GRANDWOOD RANCH
LETTER OF INTENT
PRELIMINARY PLAN

DEVIATION REQUEST AND DECISION FORM

Deviation No. 3 (4-15-2020): A deviation from the standards of or in Sections **2.3.4.B** and **2.3.7.C.4** of the Engineering Criteria Manual (ECM) is requested. The request is for intersection approach grades and “mid-block” centerline roadway grades exceeding the maximum allowable in the ECM. The details are described below. See attached Deviation No. 3 Exhibit by LSC and the attached plan and profile exhibit prepared by Matrix Design Group.

Deviation Exhibit 3
**Centerline
Roadway Grades**
Grandwood Ranch (LSC# 185020)

Deviation Exhibit 1
Proposed Intersection Spacing
Grandwood Ranch (LSC# 185020)

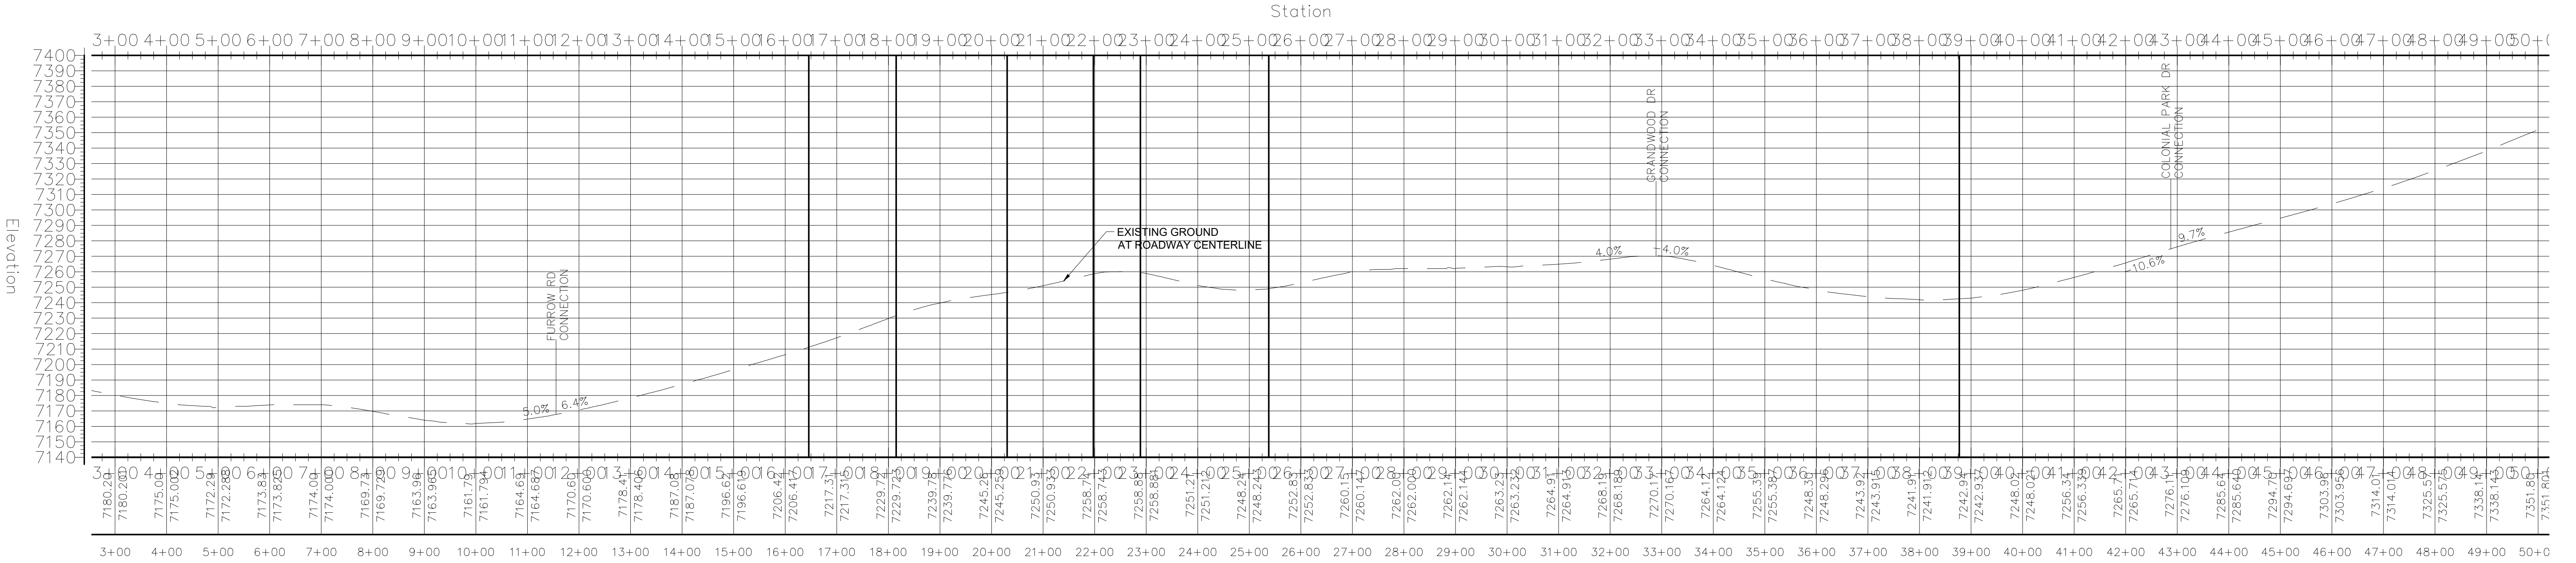
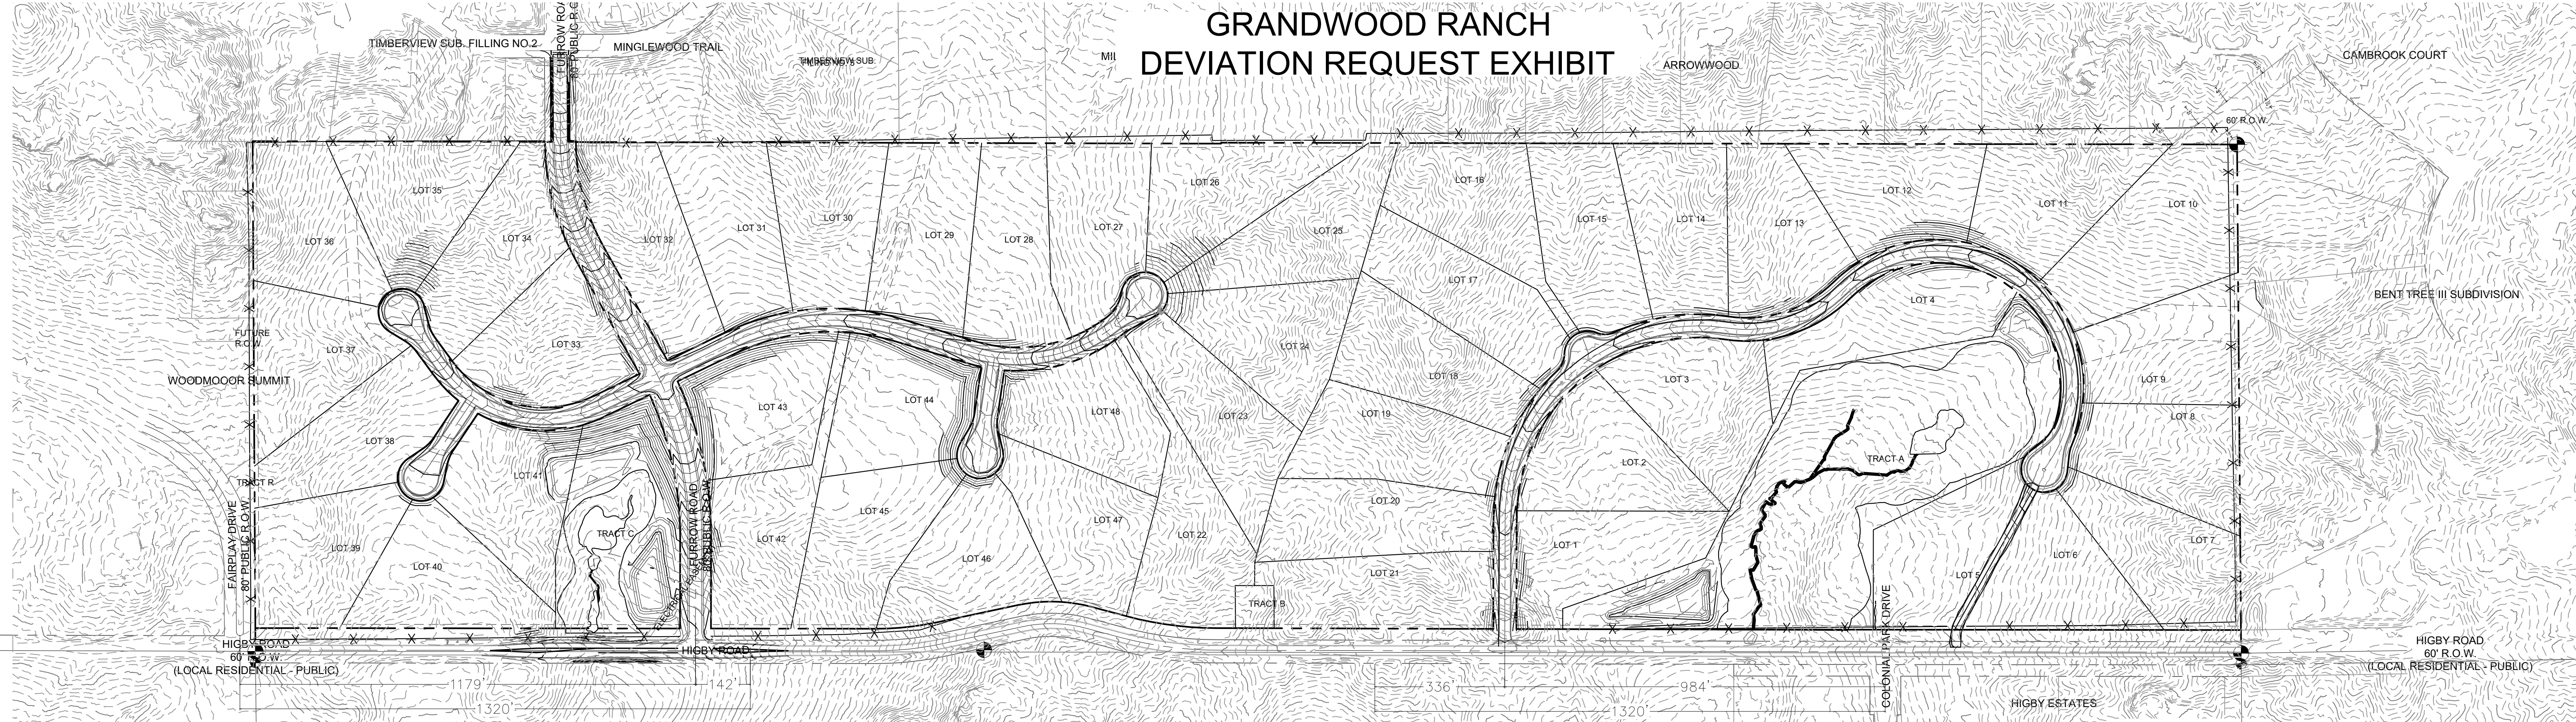
This location is appropriate as, although short of the ECM 1,320-foot spacing criteria from Colonial Park Drive, this proposed eastern access location (Grandwood Court) would maximize the distance possible from Colonial Park Drive and the vertical/horizontal curve constraints to the west (with associated short sight distances, as shown in the plan and profile drawings). Also, this access would align with the planned connection from Home Place Ranch. A copy of the Home Place Ranch layout is also attached.

Due to the existing linear distance between Higby and Minglewood Trail, it is not possible to place an intersection both ¼ mile from Higby Road and ¼ mile from Minglewood Trail. The intersection has been placed approximately halfway between the two. This selected location allows for a sufficient separation distance from Higby Road while creating the best possible scenario with respect to centerline roadway grades and intersection approach grades, given the change in elevation between the current south end of Furrow Road and Higby Road. The roadway grade shown is less than 10 percent and the intersection approach grades are not shown to exceed four percent. No auxiliary turn lanes are required at this intersection and the sight distance can be met.
